ENGINE - POWERPLANT - OIL - MAGNETIC CHIP DETECTOR - INSPECTION FOR WEAR - CATEGORY
CODE 5 - MOD.ENG-79-0029

V2500-ENG-79-0029

EXAMINATION OF MCD PROBE AND HOUSING
Fig.1

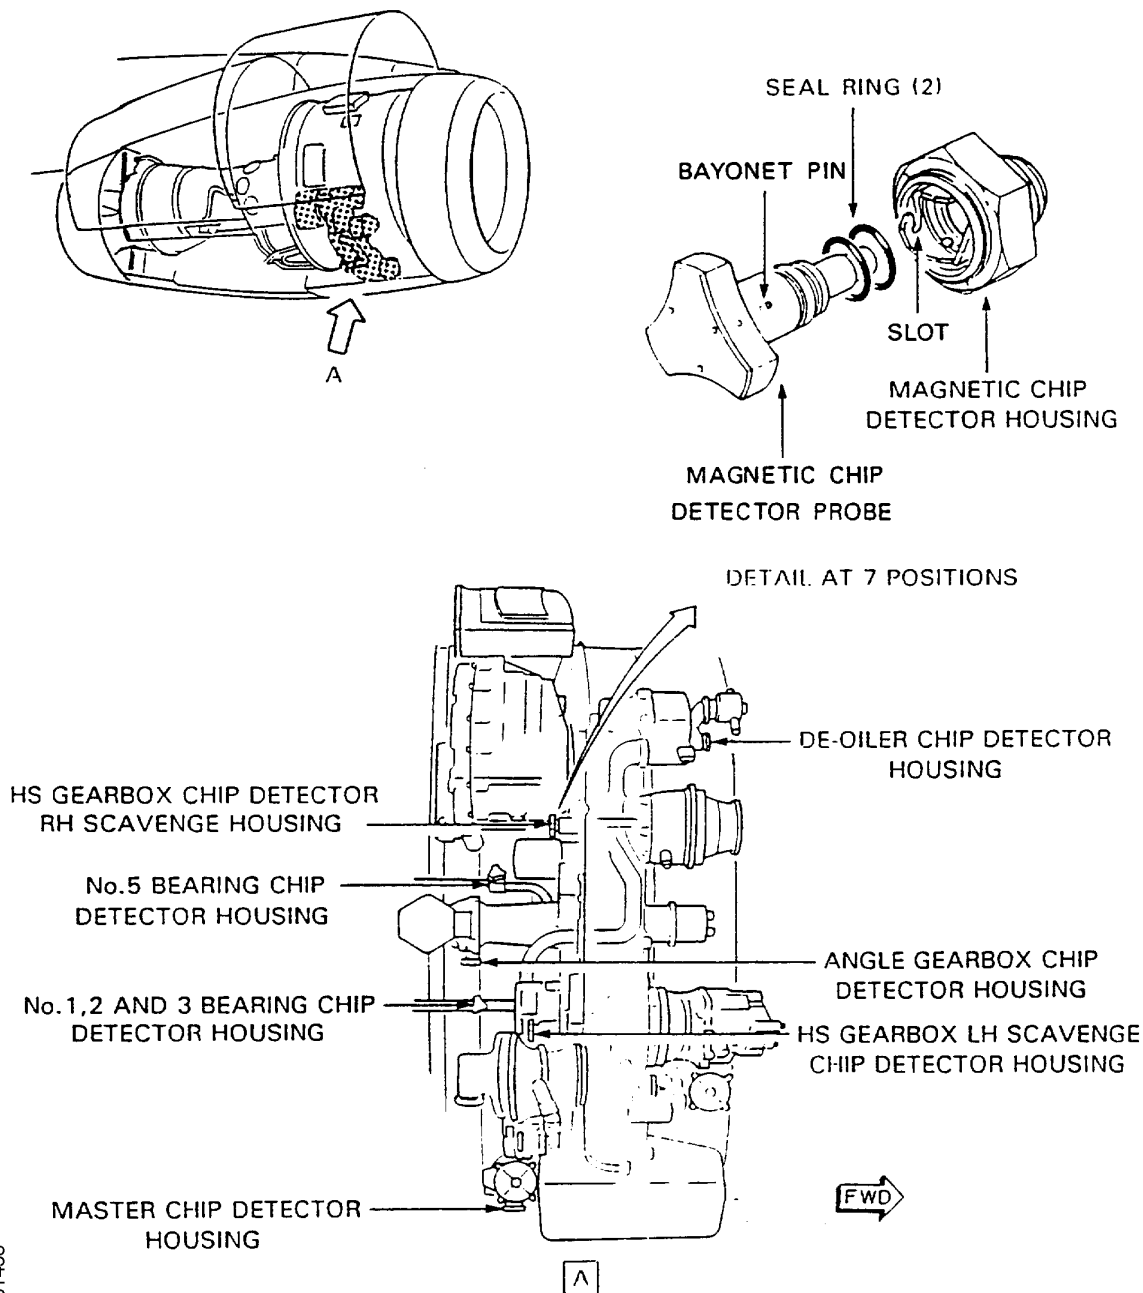
- (1) Open the left and right fan cowl doors as instructed Reference (1), Task 712-13-00-010-010.
- (2) Remove the master magnetic chip detector (MCD) probe as instructed in Reference (1), Task 79-22-45-000-010. Refer to Figure 1.

- (3) Inspect the Master MCD probe:
 - (a) If the diameter of the bayonet pins along the pin length is not less than 0.077 inch (1.97mm), the probe is acceptable. If the diameter is less than 0.077 inch (1.97mm), replace or repair the MCD probe. See Reference 1.E.(2) for repair.

- (b) If the pins are bent or loose, repair or replace the MCD probe. See Reference (2) for pin repair.
 - (c) If the pin(s) are broken, replace the probe.

- (4) Inspect the master MCD housing for wear on the slots. Use the T71884 Inspection tool:
 - (a) If the slots in the housing are not visible at the location indicated by the yellow arrows on the tool, the housing is acceptable.

- (b) If any/all of the slots are visible, replace the housing. Remove the master magnetic chip detector (MCD) housing as instructed in Reference (1) TASK 79-22-45-000-011. Refer to Figure 1.

- (7) Inspect the MCD probes and housing at the six remaining locations shown in Figure 1 per steps (2) through (6).
- (8) If, after inspecting probes and housings at any location and required replacement probes and/or housings are unavailable, proceed as follows:
